Applicant : Douglas J. Holmi
Serial No. : 09/532,907
Filed : March 21, 2000
Page : 4 of 6

Appin No.: 09/532,907
Applicant(s): Douglas J. Holmi
HEADREST SURROUND CHANNEL ELETRACOUSTIC TRANSDUCING
Annotated Sheet

FIG. 6

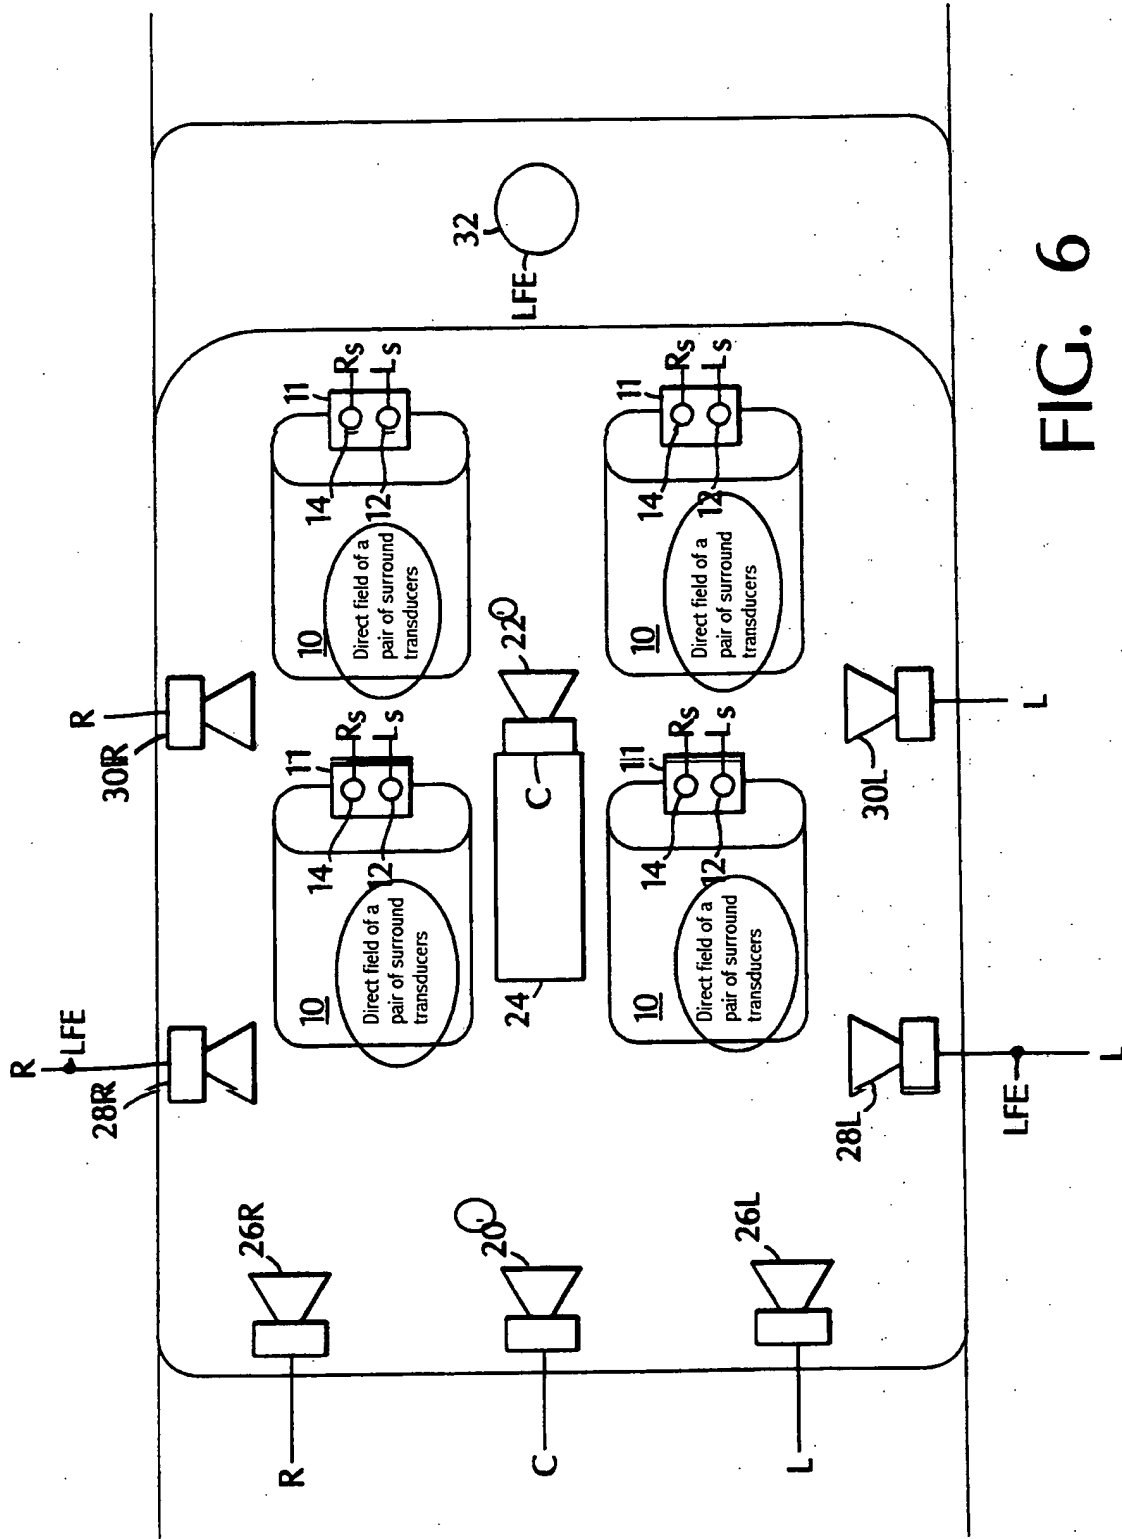
In Figure 6, electroacoustical transducers 20, 22 have been renumbered 20', 22' respectively, and the direct fields of pairs of surround transducers have been indicated.

The drawings are objected to as failing to comply with 37 CFR 1.84(p)(4) because reference characters "20" and "22" have been used to designate both angles and speakers between Figures 3A-3C and Figure 6. A proposed drawing correction or corrected drawings are required in reply to the Office action to avoid abandonment of the application. The objection to the drawings will not be held in abeyance. It is further noted that any corrections to the reference characters in the drawings should be reflected by amendments to the specification.

Therefore, the "seats positioned ... in the direct sound field of one of said plurality of electroacoustical transducers" from claims 18 and 20 must be shown or the feature(s) canceled from the claim(s). Speakers are shown, but no indication of the sound field and its relationship to the seats, as claimed, is illustrated. No new matter should be entered.

The attached replacement sheet of drawings includes changes to Fig. 6 and replaces the original sheet including Fig. 6

FIG. 6 has been amended.
